Subject: Duke Energy Corporation
Oconee Nuclear Station - Units 1, 2, and 3
Docket Nos. 50-269, 50-270, and 50-287

Revisions to Topical Report DPC-NE-3003 In Support of
Steam Generator Replacement
Response to NRC Staff Request for Additional
Information

Duke Power Response To Request For Additional Information

DPC-NE-3003 Revision 1 “Mass and Energy Release and Containment Response Methodology”

(14.1 ft² Break - SG Inlet - Low Initial RCS Flow w/ M3 Pump Degradation Model)

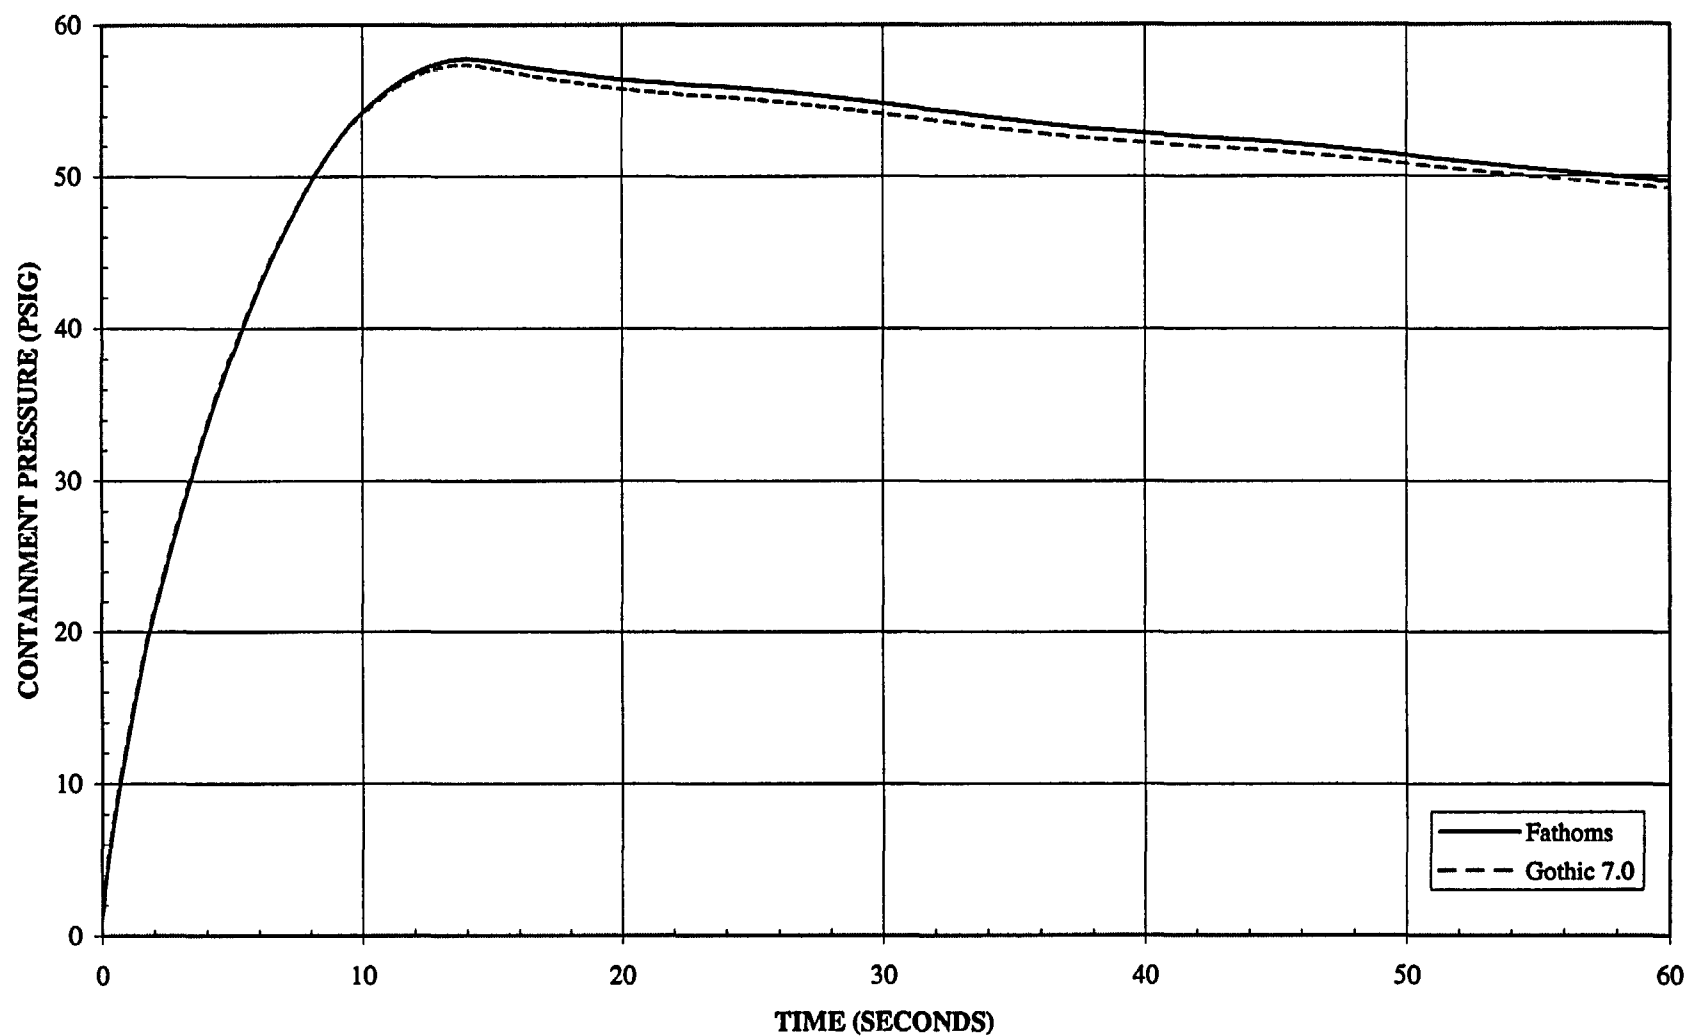
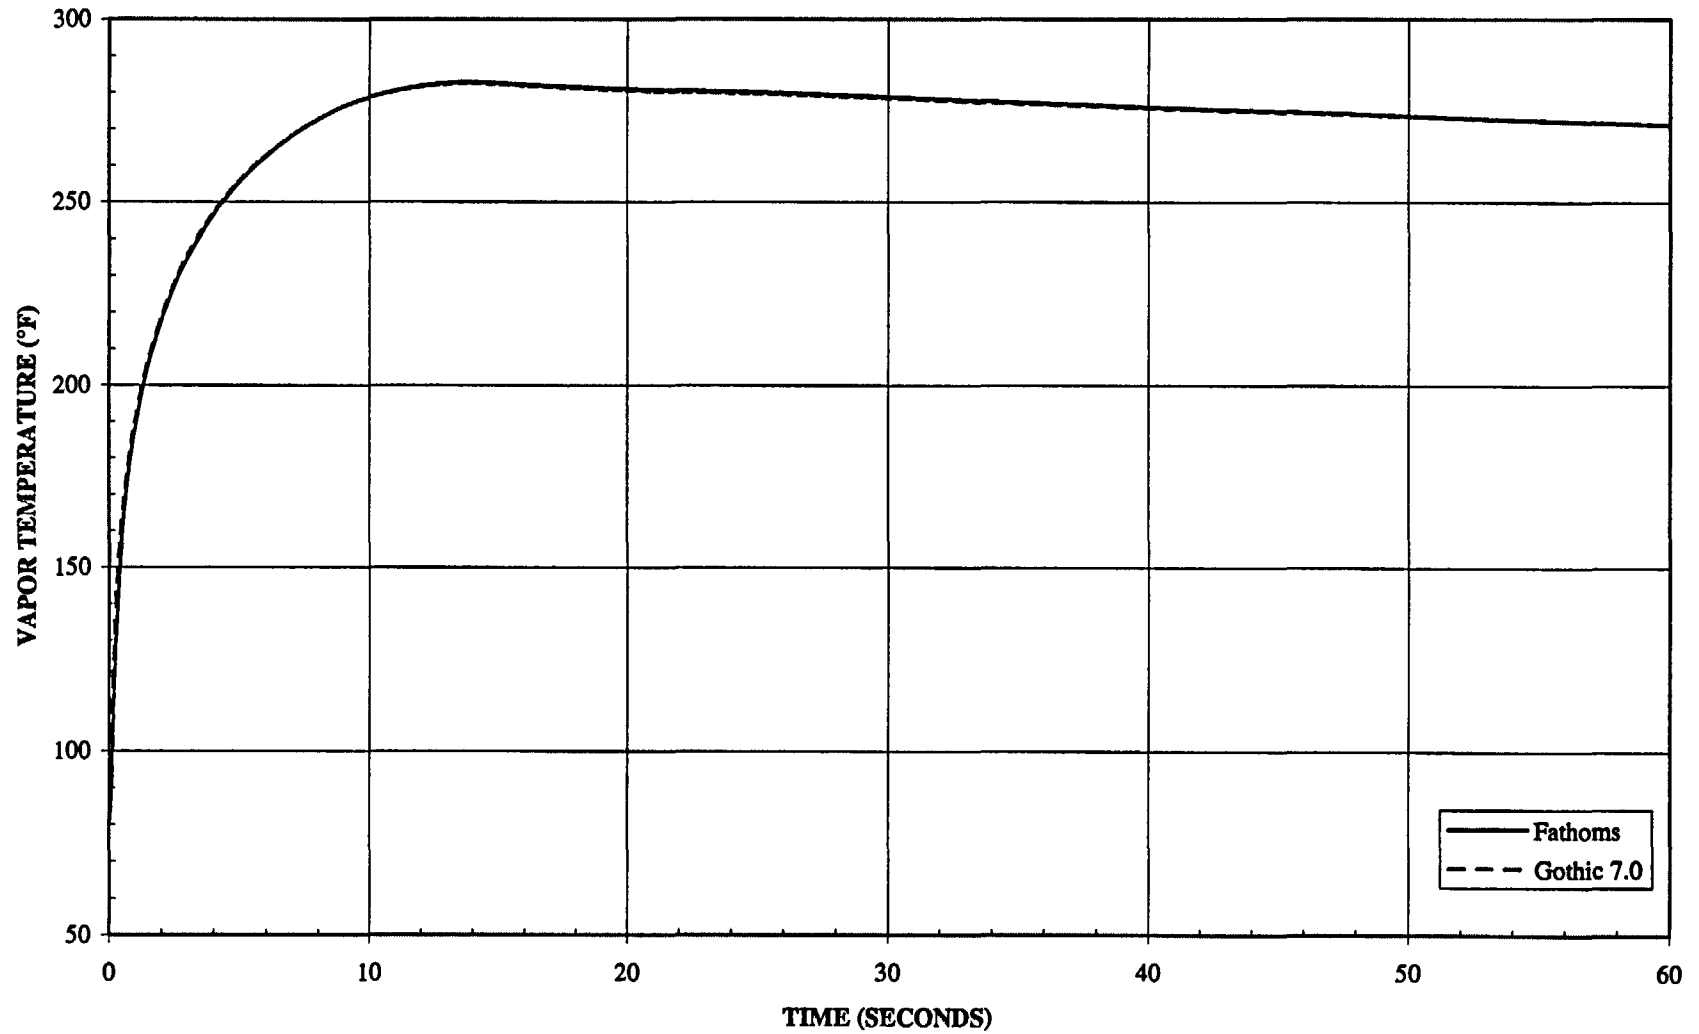
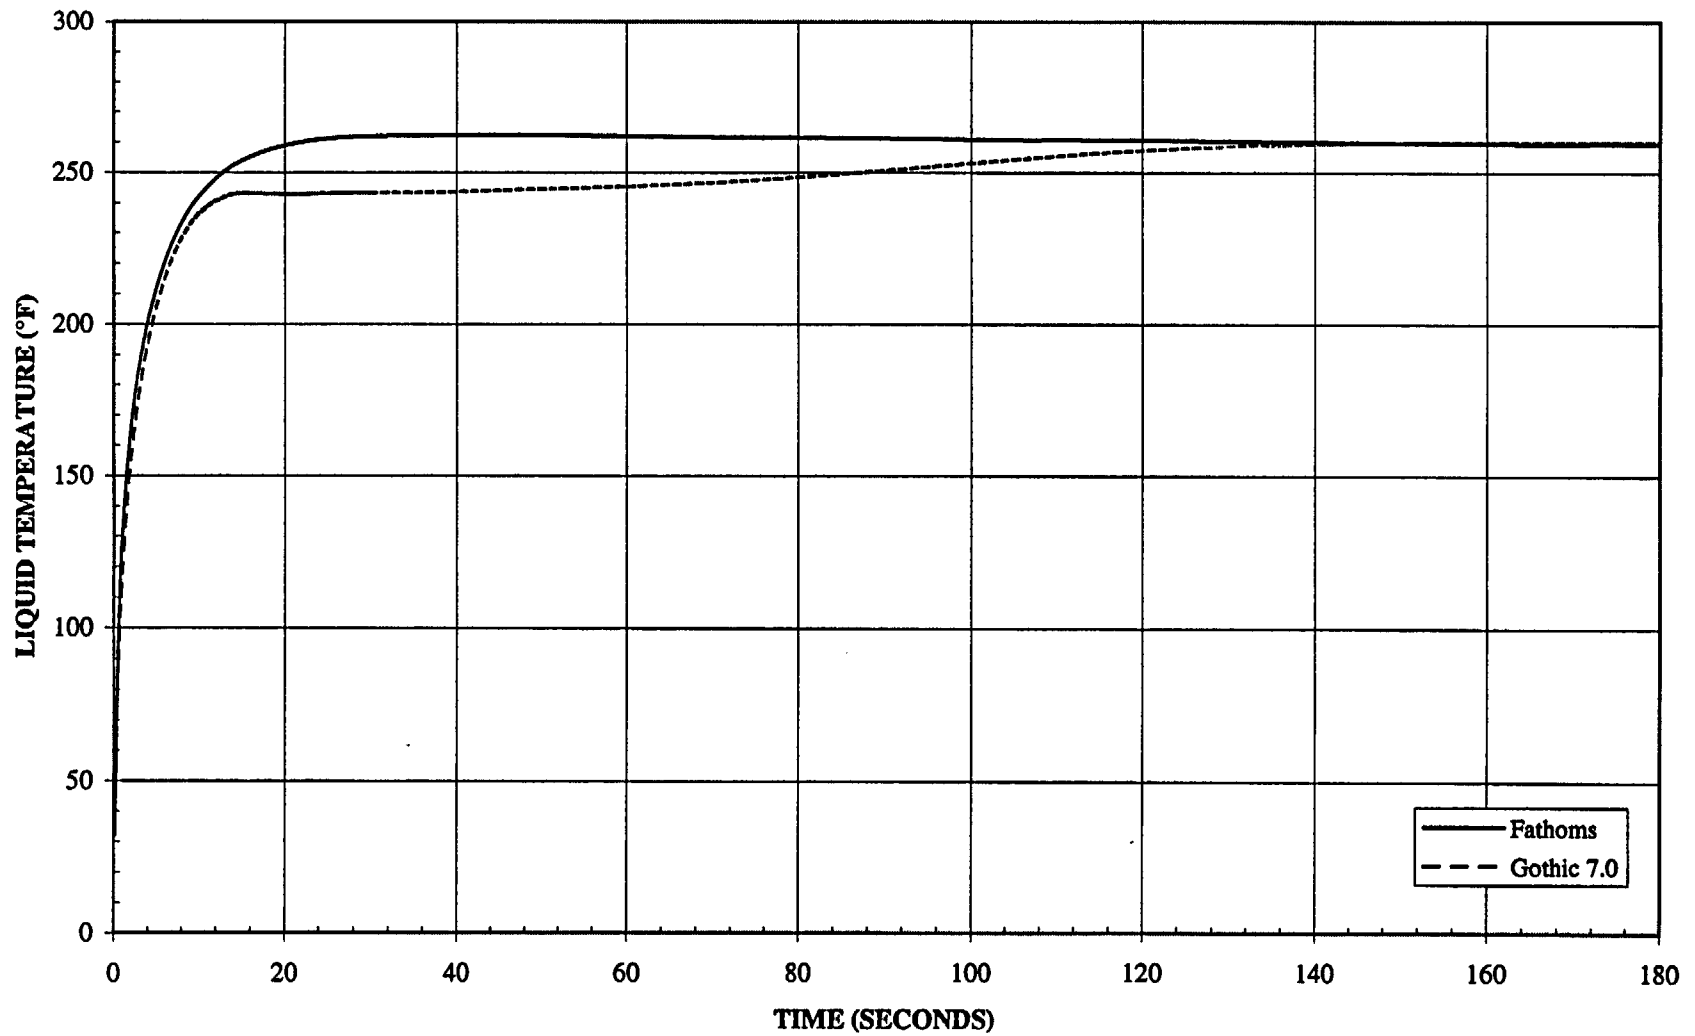
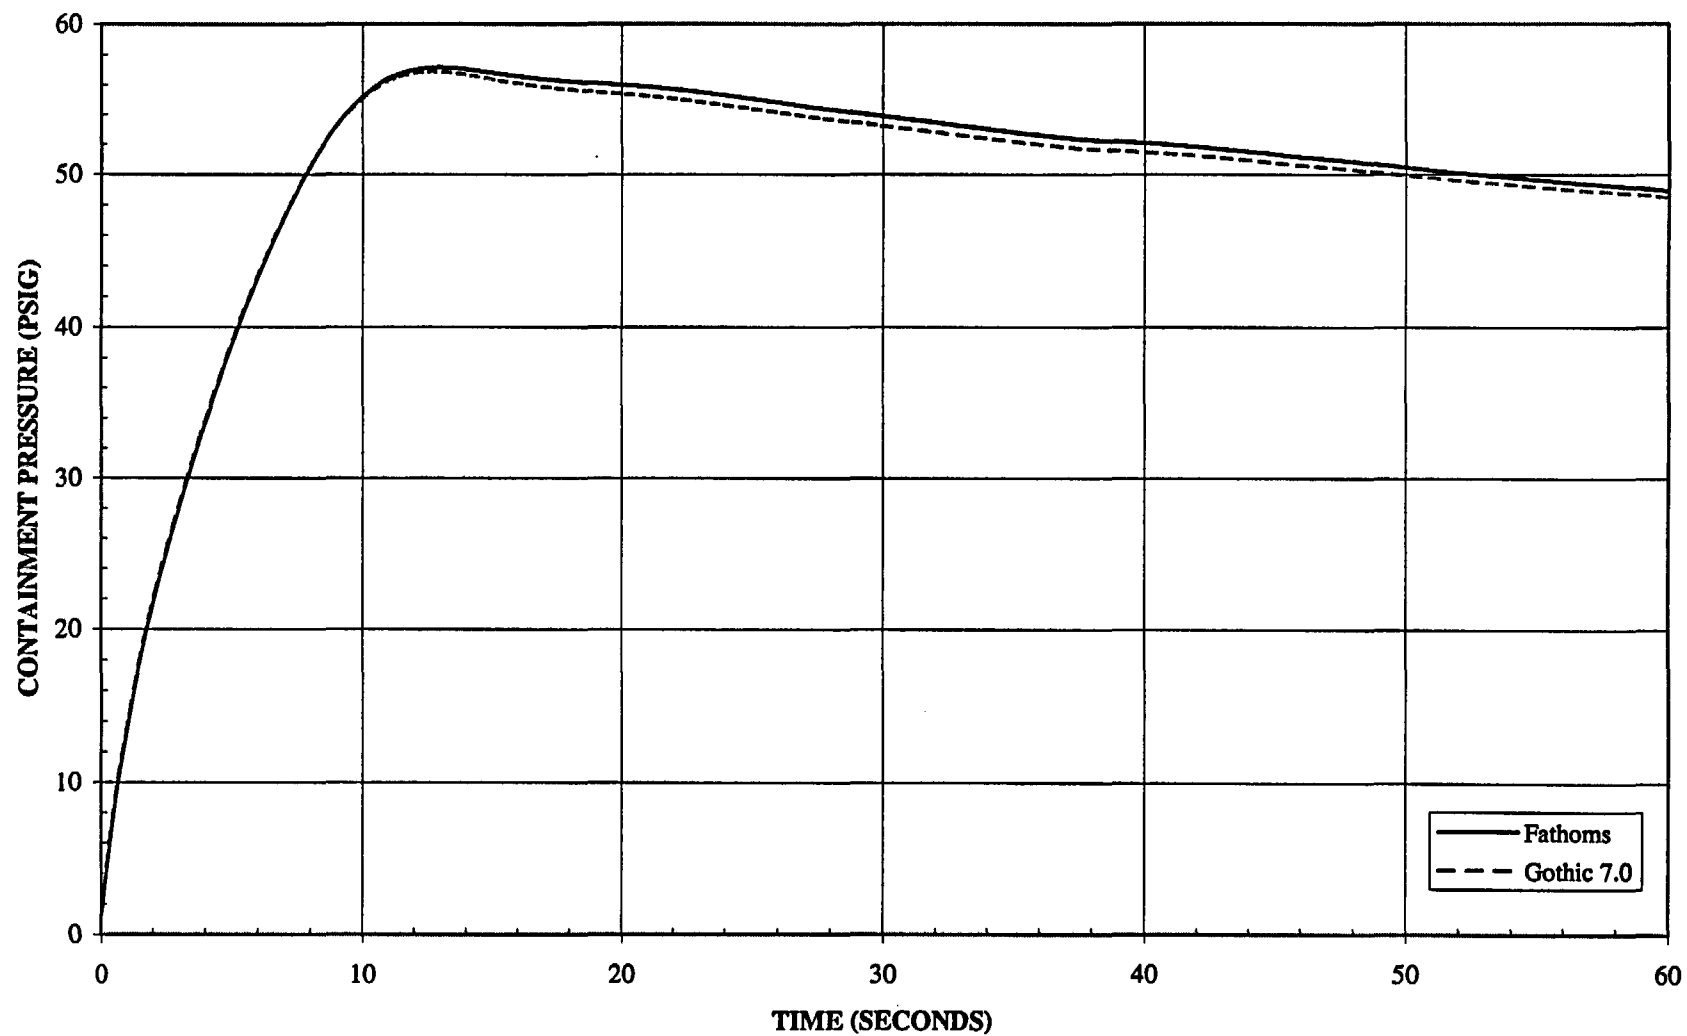
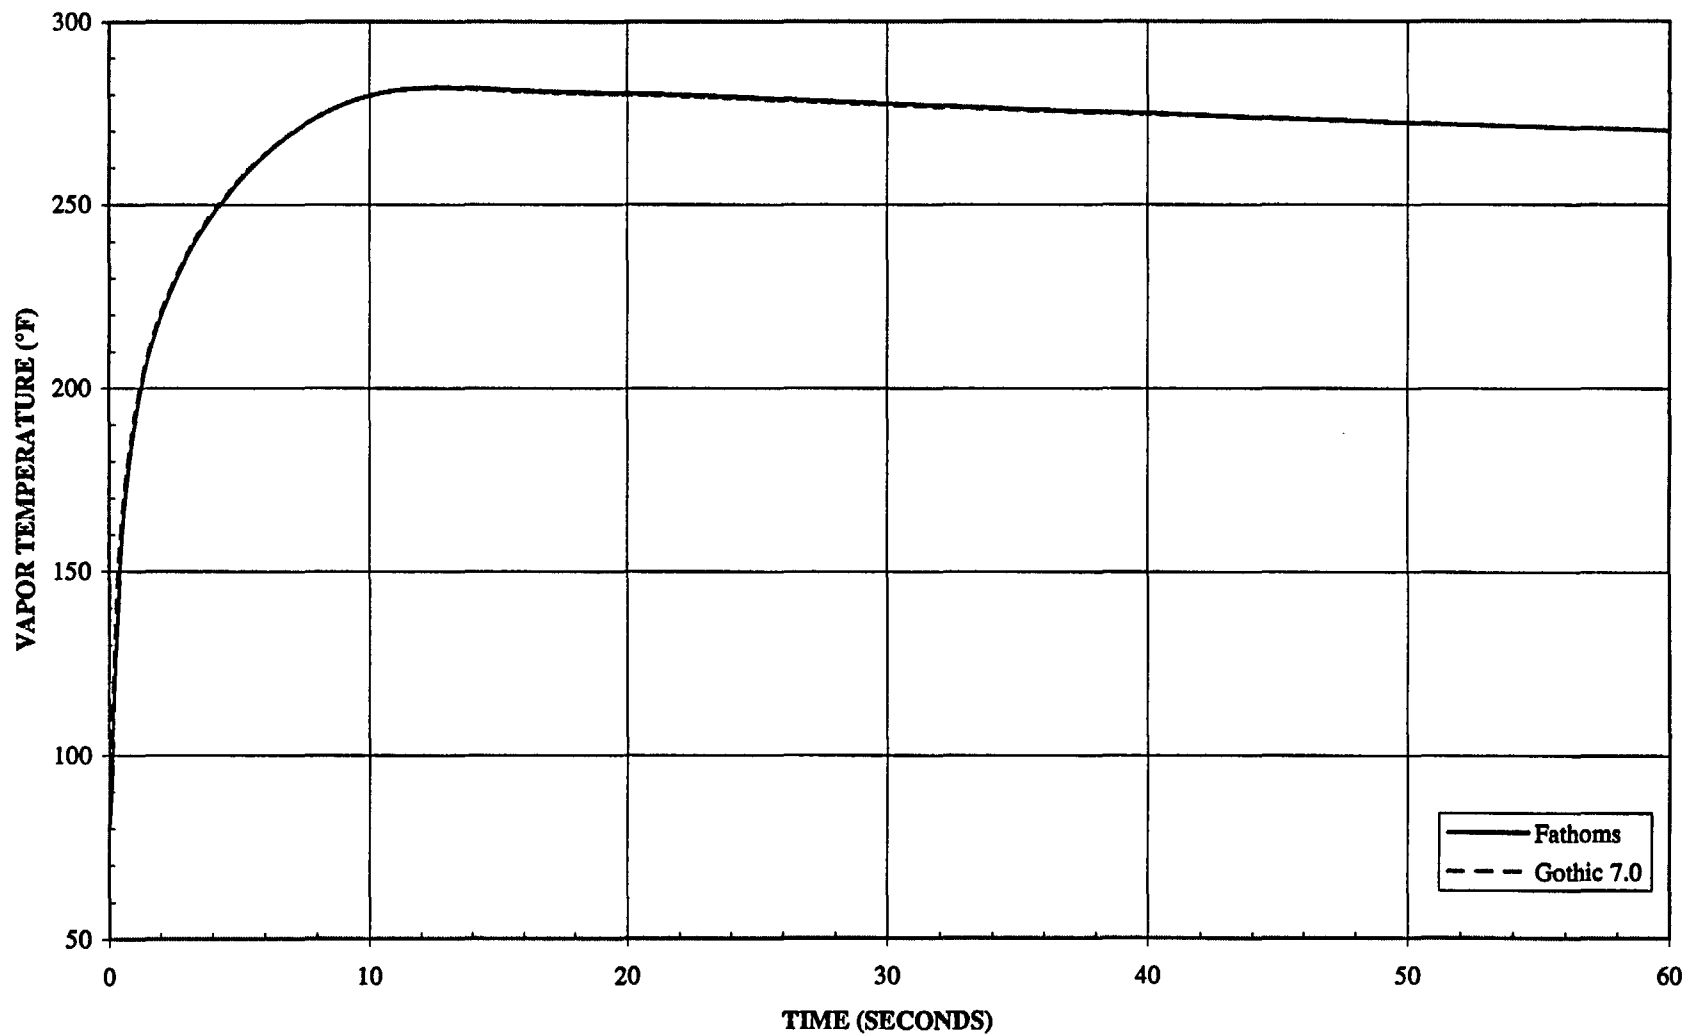
3. Please provide the results using the GOTHIC 7.0 code of peak pressure and temperature calculations for the sensitivity cases listed in Table 3.1-1 of DPC-NE-3003 in tabular and graphical form. If the results or conclusions are significantly different from those presented in DPC-NE-3003P, explain the difference.

Response: Table 3.1-1 of DPC-NE-3003 describes a spectrum of LOCA peak pressure cases including a range of break locations and sensitivity analyses for several important modeling assumptions. The staff's request is understood to focus on the difference in the predicted results from the FATHOMS and GOTHIC 7.0 code versions. Rather than show the comparison for the cases in Table 3.1-1, a different set of cases has been selected which is more focused on the current knowledge of the key sensitivity parameters. Also, the results presented are for the ROTSGs, which is the subject of Revision 1 to the topical report.

The results of the 14 code comparison analyses are shown in Table 3-1 below and in the figures that follow. In general, the pressure and vapor temperature response predictions were very similar in both magnitude and trend. GOTHIC 7.0 predictions for peak pressures and vapor temperature were slightly lower (~0.5 psig and 0.5°F). These differences are consistent with the code model differences described in the response to Question #1. Both codes predict a saturated containment atmosphere due to the large amount of drops injected. The slightly lower pressure, vapor temperature, and liquid temperature from GOTHIC 7.0 may be attributed to additional drop hold up in the atmosphere. This effectively increases the heat capacity of the atmosphere and reduces the temperature rise for a given energy addition. A comparison of the total liquid and drop masses, and liquid temperatures, show the predictions of the two codes to be essentially the same. This is consistent with the changes in the drop deposition and entrainment models discussed in Question #1. These results show that the two code versions give essentially similar results for the same break location and initial and boundary conditions.
